DOCUMENT 00 91 13

ADDENDA
03/07/2025

2025 MDUSD Roofing Project #1 at Shadelands-Sunrise Schools and Valley View Middle School ("Project" or "Contract")

ADDENDUM #1
03/07/2025

Mt. Diablo Unified School District
VALLEY VIEW MIDDLE SCHOOL
181 VIKING DR, PLEASANT HILL, CA 94523
AGENT: DOUG CLARK
DWG BY: GCK
CHK BY: DC
DATE: 1-13-25
REVISION:
SHEET: 2
OF 8

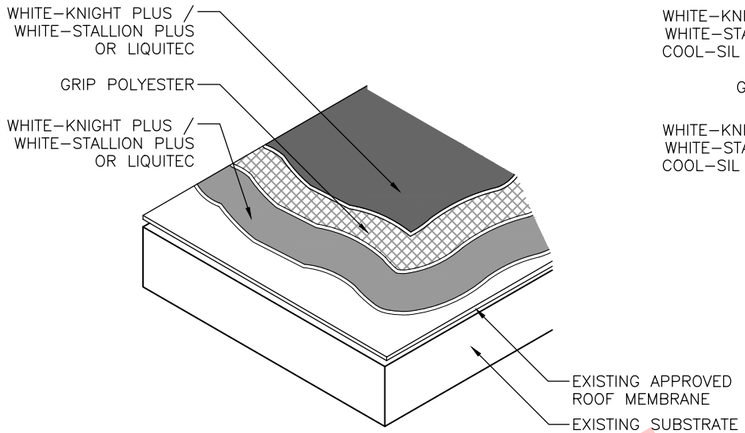
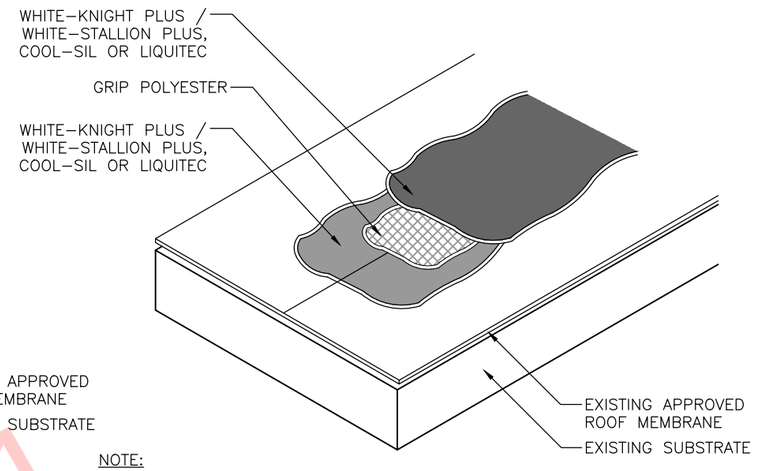
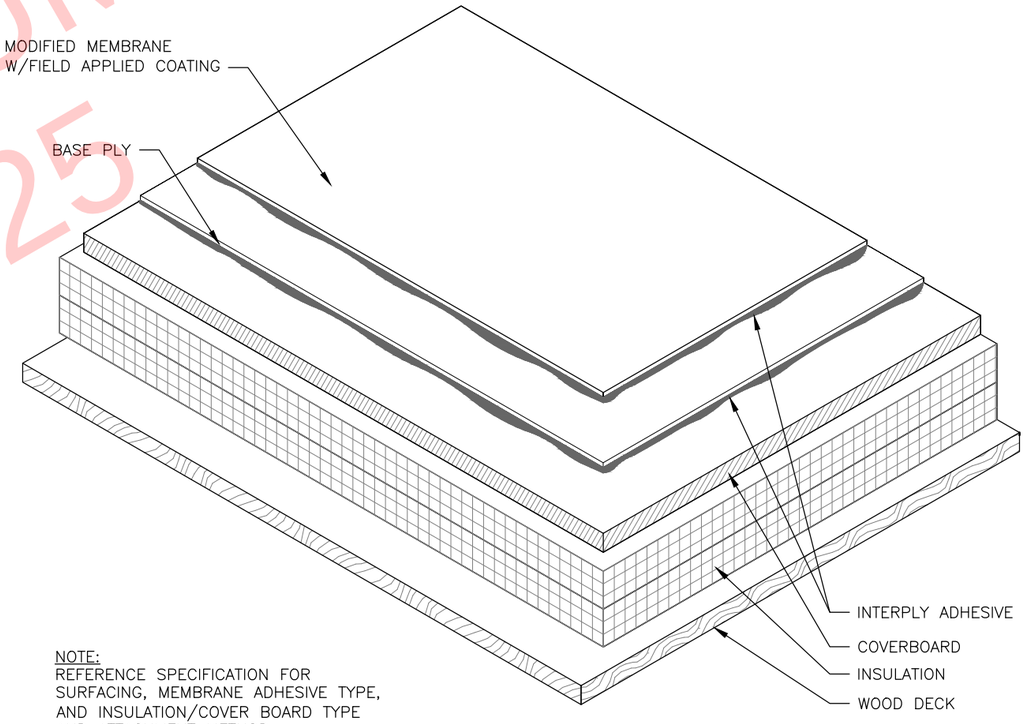
At MPR, install 2.5" polyiso and coverboard.

Add Alt #1 - Apply Liquitec FG and Uni-Bond to all duct seams and joints. See updated addendum #1 Specs.
